SHORT PLAT DEVELOPMENT STANDARDS LIST

File: SUB16-01774, K5 Oasis Short Plat

The intent of this addendum to an American Forest Management (AFM) arborist report originally dated January 12th 2018, is to respond to the City of Kirkland Plan Review Comments (File #SUB16-01774) regarding retained trees on the subject parcel. Comments regarding potential impacts of planned construction activity and updated Tree Density Calculations are included as well.

7435 NE 129TH ST
 TREE PLAN - LOTS 4 & 5

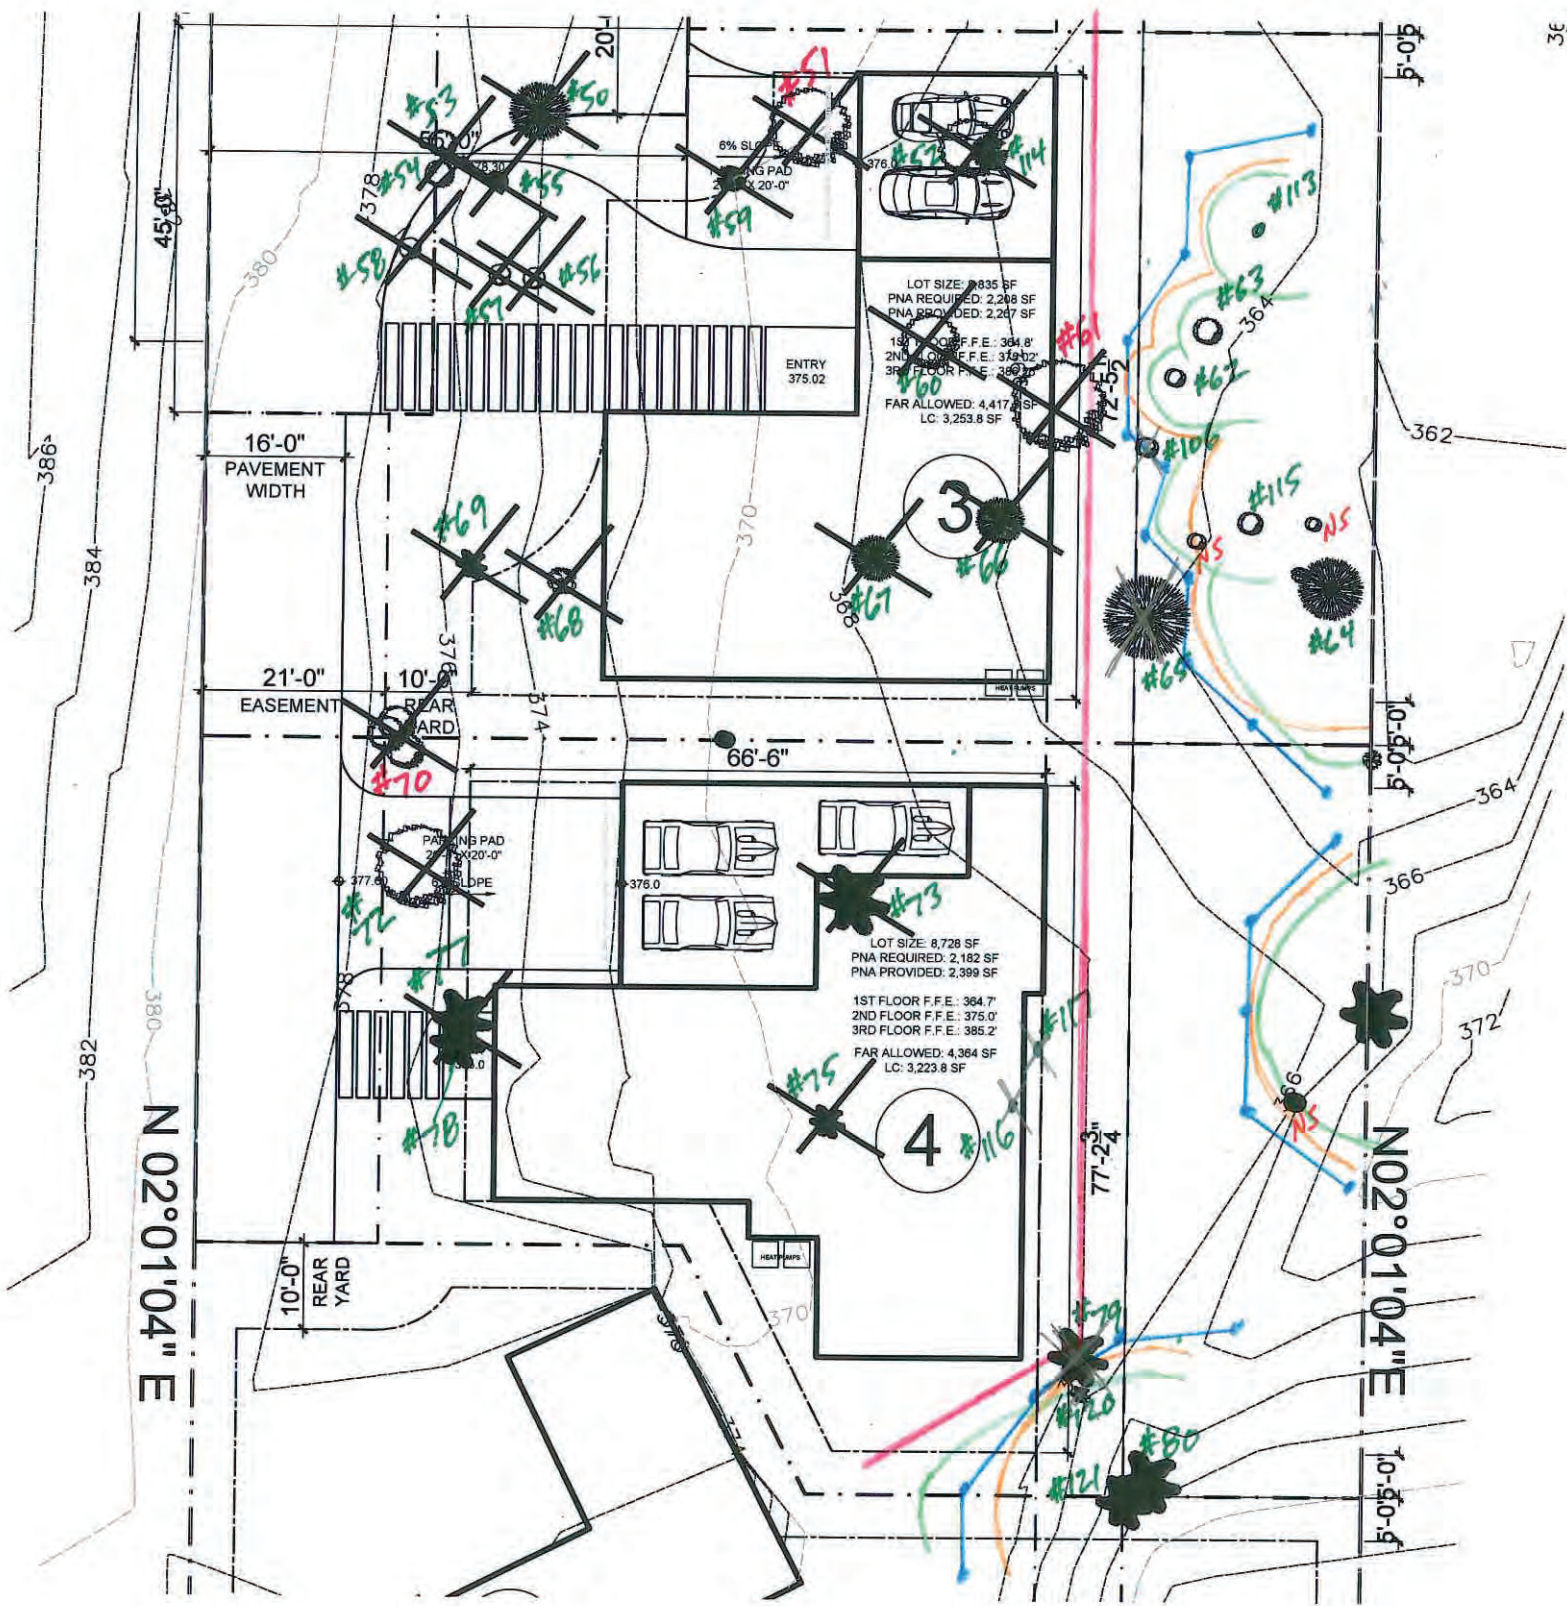
There is a 10' utility easement adjacent to the PNA. The civil plan shows the utility cutting across the northeast portion of the property adjacent to Tree #9. In order to save Tree #9, the utility should come down 129th Street and tie in at a right angle to the utility easement, avoiding the root zone. The utility trench shall be shifted to the west side of the easement adjacent to save trees #23, #29 and #40 and #62 to avoid the outer limits of disturbance. The project arborist will be onsite to oversee work adjacent to save trees and provide any necessary root tunneling (hand-digging) or root pruning services.

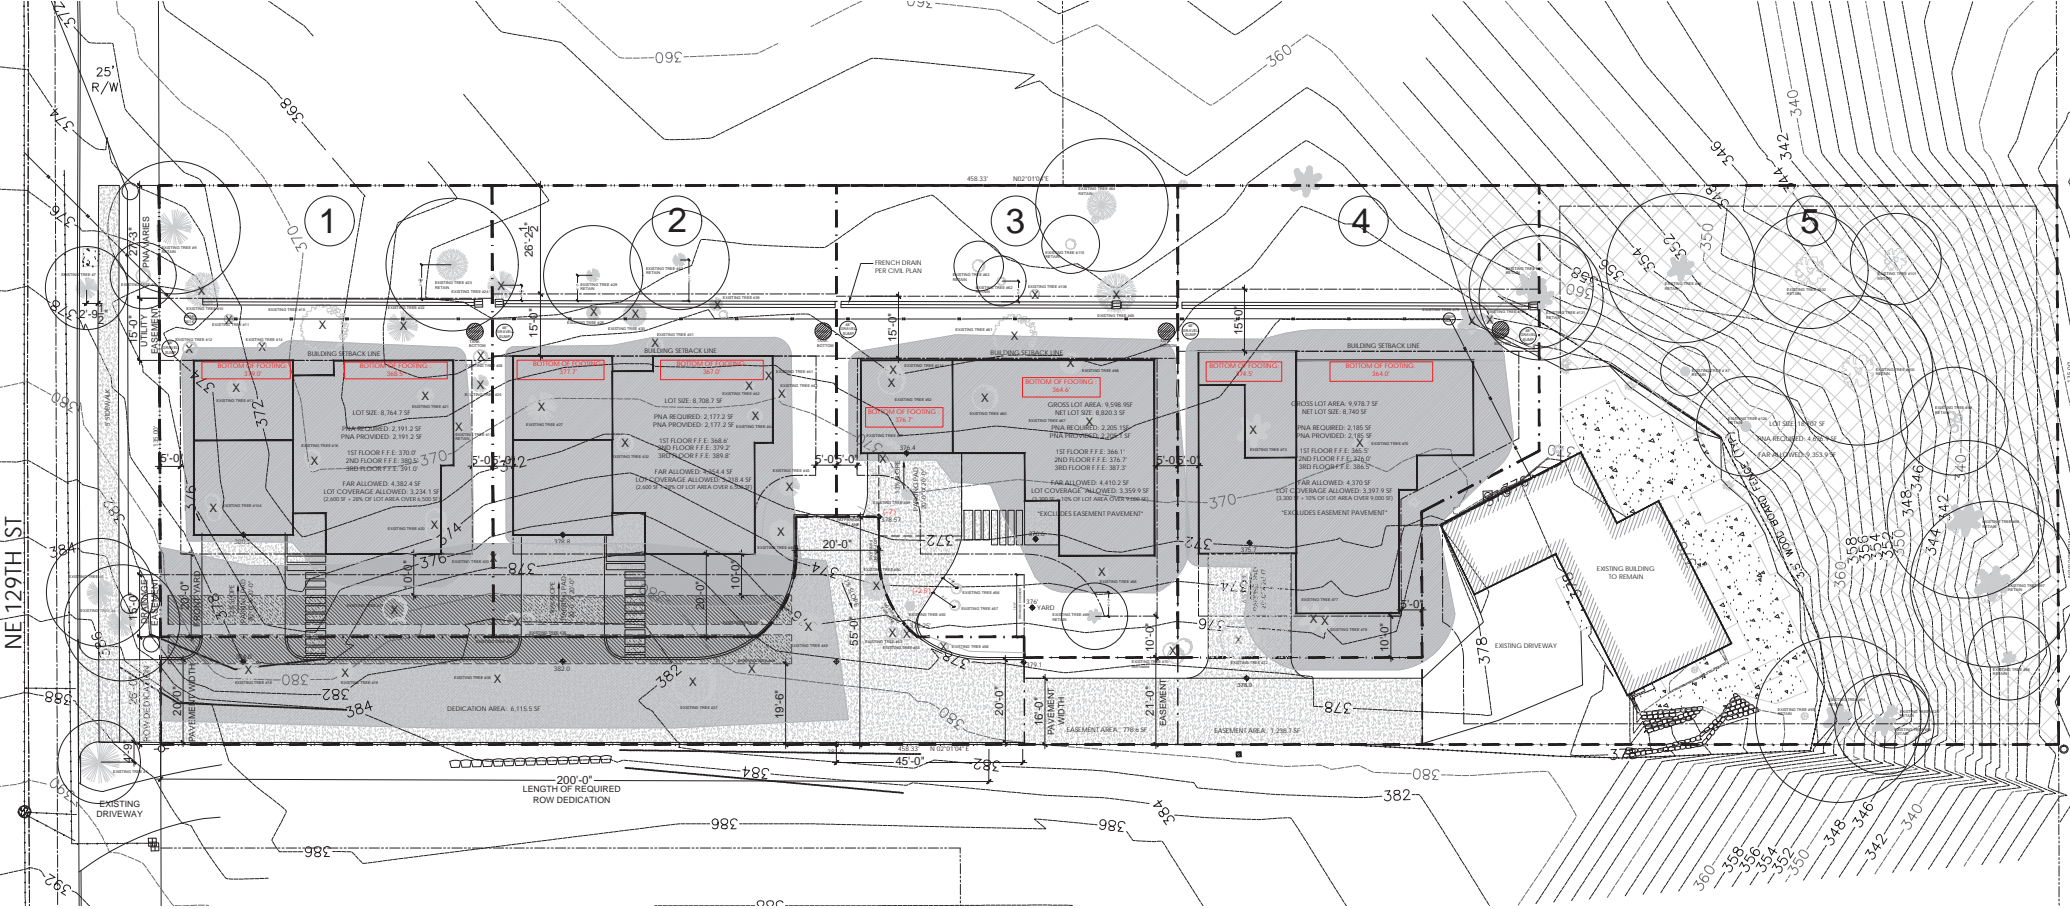
2. V.1 Review Comment: In addition to the trees proposed for retention, if the sewer line and French drains were relocated, the following trees potentially could be retained. See Figure 1 and 2 for recommended tree protection fencing for these trees based on retained trees LOD's.

- a. Lot #1: Tree #10 (in PNA), #11
 - b. Lot#2: #24 (in PNA), #28, #39
 - c. Lot #3: #65 (in PNA) and #106 (in PNA)Follow-up Comment: The additional arborist comments submitted will be reviewed in the next round of reviews when the above requested information is supplied.
